CITY OF ALBUQUERQUE

Re: Restaurant Depot
1901 Menaul Blvd. NE
Traffic Circulation Layout
Engineer's Stamp 06-30-22 (H15-D039)

Based upon the information provided in your submittal received 09-13-22, the above referenced plan cannot be approved for Building Permit until the following comments are addressed:

TCL-1

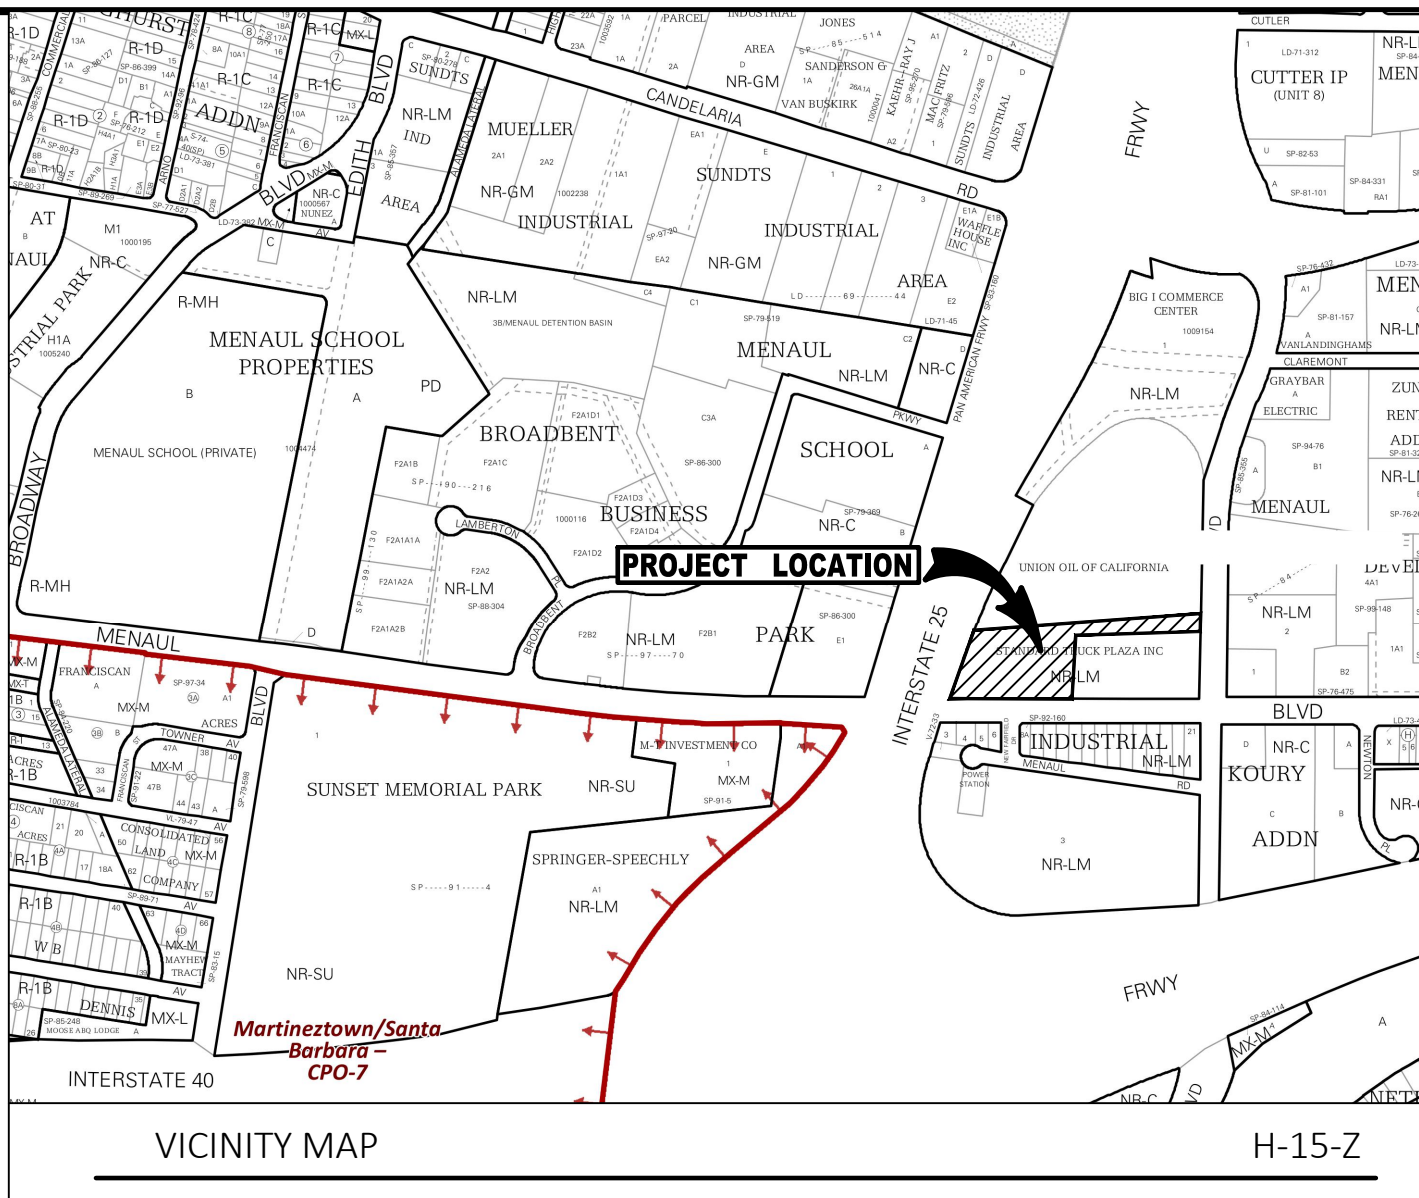
1. Please provide NMDOT Approval for the proposed sidewalk and driveway access off Pan American Frontage Rd. N.
2. Provide shared access agreement, or approved plat action.

3. Identify the right of way width, medians, curb cuts, and street widths on Menaul Blvd, University Blvd, and on Pan American Frontage.
4. Clear sight triangle need to be provided at driveway access off University Blvd.

5. Show the bike Racks on the site plan.
6. Provide a copy of Solid Waste Approval and Fire Marshal Approval.
7. The ADA accessible parking sign must have the required language per 66-7-352.4C NMSA 1978 **"Violators Are Subject to a Fine and/or Towing."** Please call out detail and location of signs.

8. The ADA access aisles shall have the words **"NO PARKING"** in capital letters, each of which shall be at least one foot high and at least two inches wide, placed at the rear of the parking space so as to be close to where an adjacent vehicle's rear tire would be placed. (66-1-4.1.B NMSA 1978)

9. ADA curb ramps must be updated to current standards and have truncated domes installed.
10. Motorcycle parking spaces shall be designated by its own conspicuously posted upright sign, either free-standing or wall mounted per the zoning code.

11. All bicycle racks shall be designed according to the following guidelines:
 - a. The rack shall be a minimum 30 inches tall and 18 inches wide.
 - b. The bicycle frame shall be supported horizontally at two or more places. Comb/toaster racks are not allowed.

- c. The rack shall be designed to support the bicycle in an upright position. See the IDO for additional information.

- d. The rack allows varying bicycle frame sizes and styles to be attached.
 - e. The user is not required to lift the bicycle onto the bicycle rack.
 - f. Each bicycle parking space is accessible without moving another bicycle.
- 12. Bicycle racks shall be sturdy and anchored to a concrete pad.
 - 13. A 1-foot clear zone around the bicycle parking stall shall be provided.
 - 14. Bicycle parking spaces shall be at least 6 feet long and 2 feet wide.
